RN design
Imagine • Inspire • Create

model
36-02

project
Legacy

A0

SECOND FLOOR ELEV. 'A'

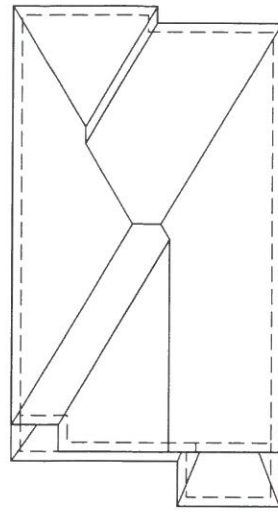
ENGINEERED FLOOR LAYOUT, TRUSSES AND LINTELS TO BE SUBMITTED PRIOR TO FRAMING. DESIGNER TO COMPLETE RESPONSIBILITY REVIEW FORM AND TO BE SUBMITTED WITH TRUSS, FLOOR AND LINTEL DOCUMENTS.

WINDOW ON LANDING MUST BE HIGHER THAN 3' ABOVE OR ENGINEERING ON WINDOW OR GUARD REQD

ALL POINT LOADS TO BE TRANSFERRED TO FDN
